Conditions of approval

**DA2024.109– Quarry – Request to blast monthly – LOT: 18 DP: 851163, LOT: 4&7 DP: 252442
– 28 Coral Park Road WOLUMLA**

Transport for NSW (TfNSW) is responding to the DA2024.109 re-referred on 25 March 2025.

Attachment 4: Blasting plan

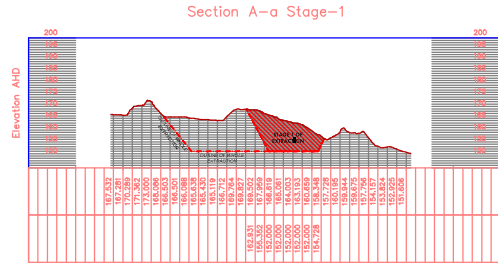
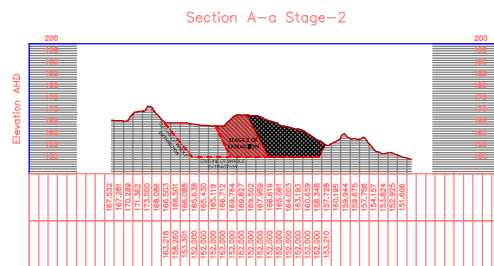
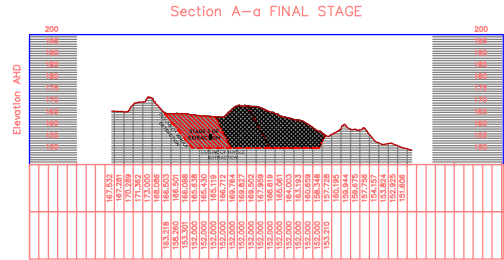
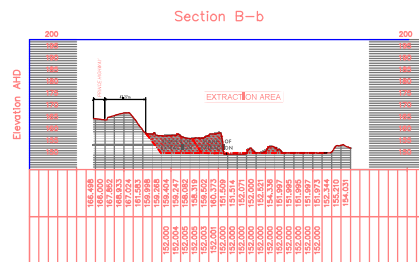
TfNSW has reviewed the information and has identified a safety risk for motorists as a result of ongoing blasting. The Developer has identified a risk of flyrock and TfNSW believes that under the current proposal, the flyrock could impact the Princes Highway.

The proximity of some of the proposed blasting sites to the Princes Highway are less than 60m and cratering blasts have a maximum throwing distance of 83m. In addition to flyrock management, ongoing geotechnical monitoring will be required throughout the blasting timeline. Given this, under the current proposal, TfNSW believes that road closures would be required to ensure the safety of the public.

- The development proposes blasting once per month, 12 months per year for 30 years. Excerpts from the blasting plan are shown in **Attachment 3**,
- The above excerpts show a discrepancy between the distances to the Princes Highway and TfNSW are concerned about motorist safety throughout the proposed blasting timeline,

- The complete blasting plan is shown in **Attachment 4**, this plan addresses blasting impacts in the proximity of the Princes Highway road reserve and acknowledges a reduced charge can be implemented to reduce risk of flyrock impact the state road,

1. Provide a blast summary for TfNSW review to geotech.southern@transport.nsw.gov.au. The blast summary must demonstrate the blast will not impact the Princes Highway. Submission of the blast summary must be 2 weeks prior to EACH blast. As a minimum, the blast summary must address the following:
 - a. Blast location details (inclusive of distance and proximity of the state road, location of faces to be blasted, direction in which the blast will occur),
 - b. Blast design (charge administered, indicative blast hole locations, blast hole spacing, depth of blast, over burden etc.),
 - c. Predicted flyrock emission distance for each blast design,
 - d. If the flyrock is predicted to impact the Princes Highway, TfNSW requires a mitigation strategy that does not include highway closure.
2. Obtain TfNSW written acceptance of EACH blast summary.
